CHEHALIS PLANNING COMMISSION AGENDA

Special meeting of April 9, 2024

Subject: RE: Rezone and Comprehensive Plan Amendment Notice of application
Date: Friday, April 5, 2024 at 8:13:03 AM Pacific Daylight Time
From: Josh McDrummond
To: Todd Johnson
Attachments: image001.png

Chapter 17.28 LANDSCAPING REQUIREMENTS

Figure 1- Diagram of landscape types:

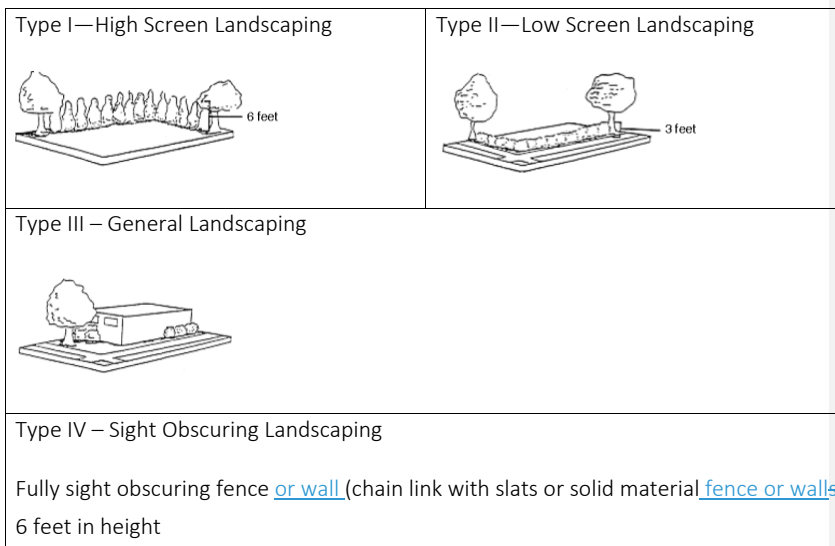
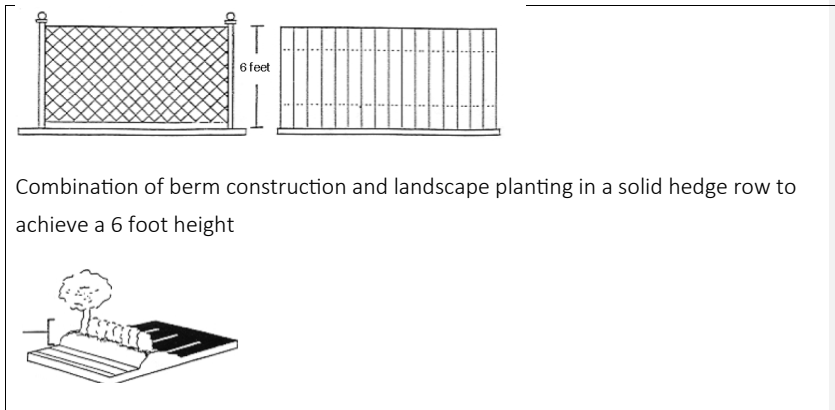
.050.D.3.a-b Smells like an old Lacey standard. Probably should define what you can count as Type IV.

Commented [TJ14]: CA comment asks for definition, defined above in table.
